Our Reference: L451/Let1/WLH

Re: Winterbourne Wind Farm Noise Assessment – Peer Review

L Huson & Associates Pty Ltd has been commissioned by the Voice for Walcha to peer review the Winterbourne Wind Farm Noise and Vibration Assessment (NVA), report reference S6207C14 dated October 2022 that was prepared by Sonus Pty Ltd. The NVA is included in the Environmental Impact Statement (EIS) dated 27 October 2022 as Appendix H that was prepared by Environmental Resources Management Australia Pty Ltd. Section 6.2 of the EIS summarises the NVA.

Cape Bridgewater Startup 16 May 2014 Inside dwelling (CBR1)

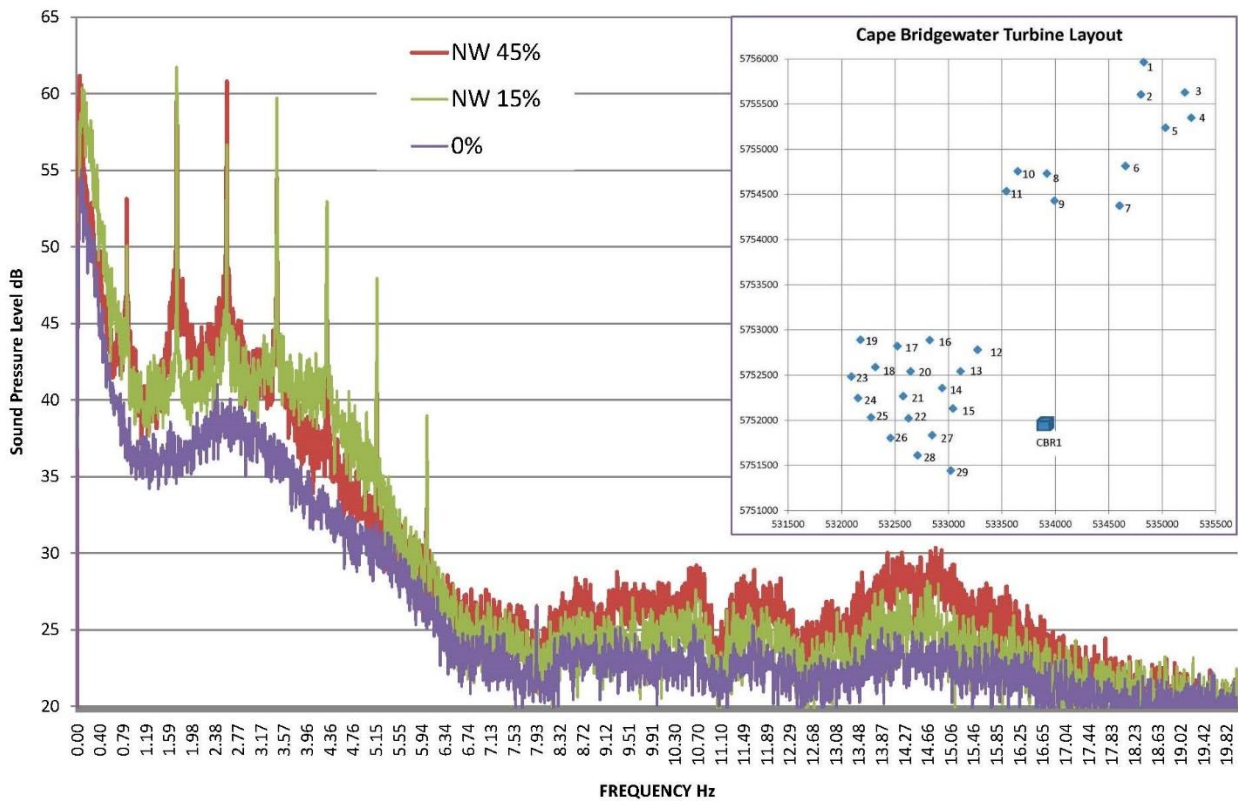
The following chart from Huson(2015)¹ was obtained from a wind farm start-up to different percentage electrical generating levels of the wind farm (eg. NW 15% means 15% electrical generation in NW wind).

It is clear that infrasound below 6 Hz increases by over 20 dB after the wind farm starts to operate. The suggestions in section 2.6 of the updated SA 2009 regarding comparative studies are misplaced. The issue of adverse health effects from wind farm generated infrasound remains contentious.
